**CENTER FOR DRUG EVALUATION AND  
RESEARCH**

**213224Orig1s000**

**PRODUCT QUALITY REVIEW(S)**

**DIVISION OF DRUG DELIVERY, GENERAL HOSPITAL & HUMAN FACTORS**  
**INTERCENTER CONSULT MEMORANDUM**

**Image 1.0**

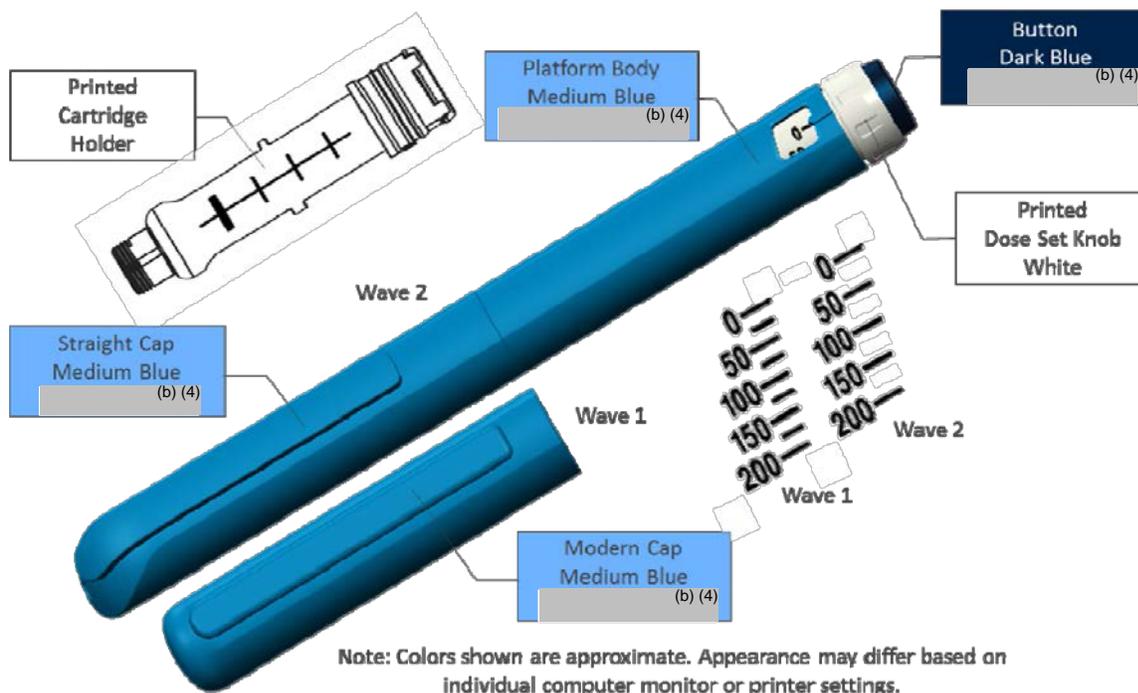
1. In your Summary of Container Closure System, you provided a comparison between the “existing” and “commercial” versions of the pen injector and stated that “*there is some minor changes to the secondary packaging components between the exhibit and propose commercial pen injector.*” More information is necessary to ensure this change does not affect device function. Please clarify whether the design change affected any internal and/or mechanical components and which version(s) were used for all applicable device testing including the provided batch analyses, stability, and all clinical studies. If the testing you have performed used different versions, please provide a complete justification for each modification and whether it is expected to affect device performance, specifically, whether essential performance requirements (Dose Accuracy, Activation/Break loose/Glide Forces, Needle Length/Gauge) and other performance requirements (Ex. cap removal force) are affected.

**Reviewer Comments:**

The deficiency requested the Sponsor to: clarify whether their design change affected any internal and/or mechanical components, clarify which version(s) were used for all applicable device testing, and provide a justification for each modification and whether it affected device performance. The Sponsor has replied that they used a 'Wave 1' version for exhibit batch pen components and 'Wave 2' for pen components for commercial batches. The Sponsor argues that changes in Wave 2 make the delivery device "more robust" and "better in look and feel" and do not affect performance. Table 1.0 in the response above shows that Wave 1 was used for the clinical BE study, stability testing, verification, and formative HF testing; while Wave 2 was also used for verification testing and summative HF. Table 2.0 shows that the verification test requirements are the same for both versions and that both versions had the same acceptance criteria. This bridges the Wave

1 to the Wave 2 device acceptably. The modifications are minor and do not appear to affect performance (main changes are pen cap shape, markings, etc.). The Sponsor additionally provided a more complete device description. This is acceptable.

Details of changes in internal as well as external pen components between the exhibit and proposed commercial pen injector are summarized in **Attachment-1**. Device supplier uses terminology ‘Wave 1’ for exhibit batch pen components and ‘Wave 2’ for pen components for commercial batches. These changes are implemented to make the delivery device more robust and better in look and feel and are not expected to affect device performance. As there is no design change with respect to functional performance of the device, the specifications for delivered dose volume, break loose and glide force remains same for both the versions. Also other performance requirements like cap removal force specifications are same for both the versions.

Changes from Wave 1 to Wave 2, in outer appearance of the fully assembled device are provided below in image 1.0.
